OSSF Inspection Sheet

Permit#: **118992**

Address: **1230 GREENBRIAR DR**

Permit of Authorization to Construct an On-Site Sewage Facility Permit Valid For One Year From Date Issued

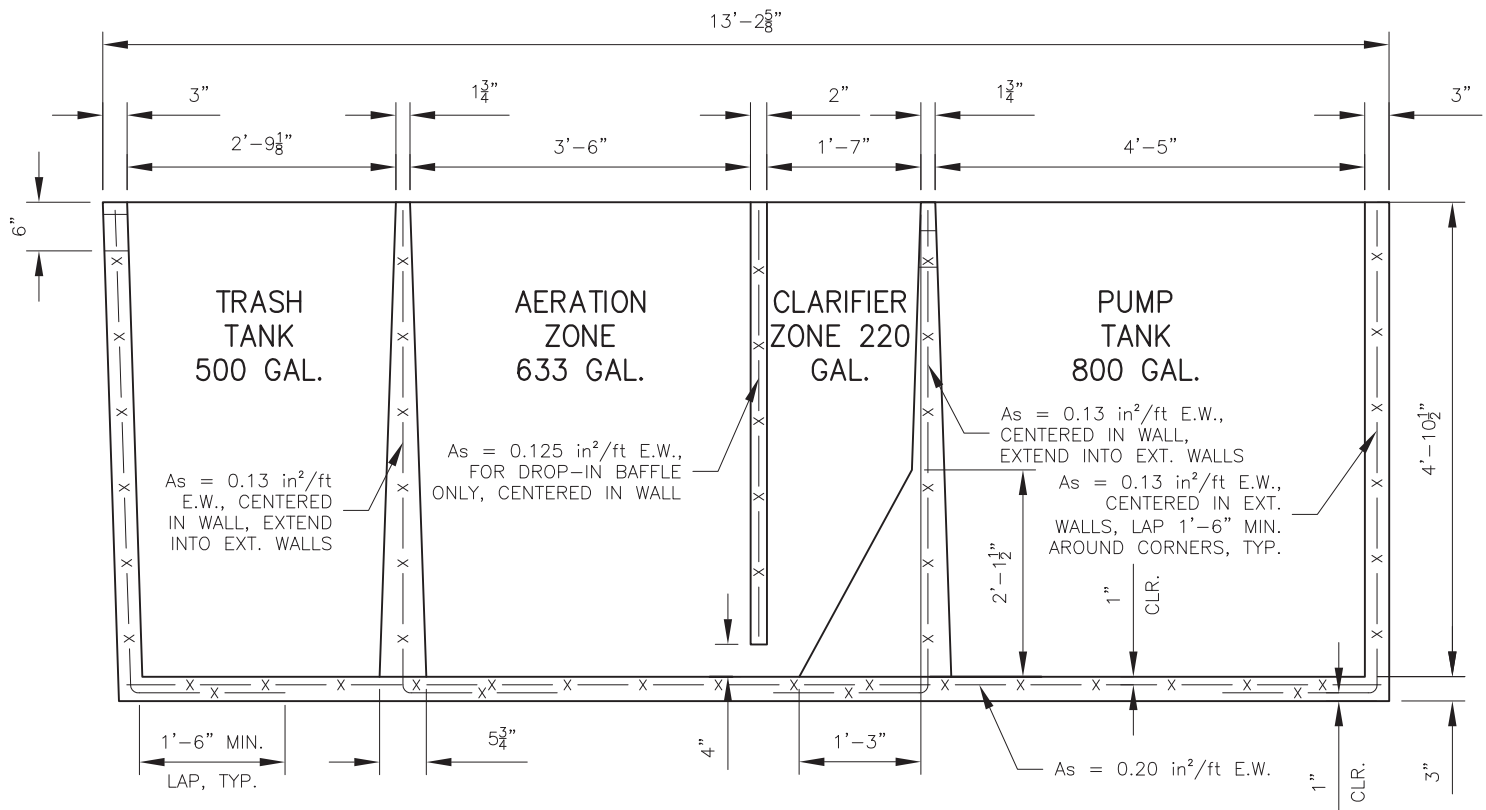
Thank you for your submission. We have reviewed the planning materials for the referenced permit application, and unfortunately, they are insufficient. To proceed with processing this permit, we require the following:
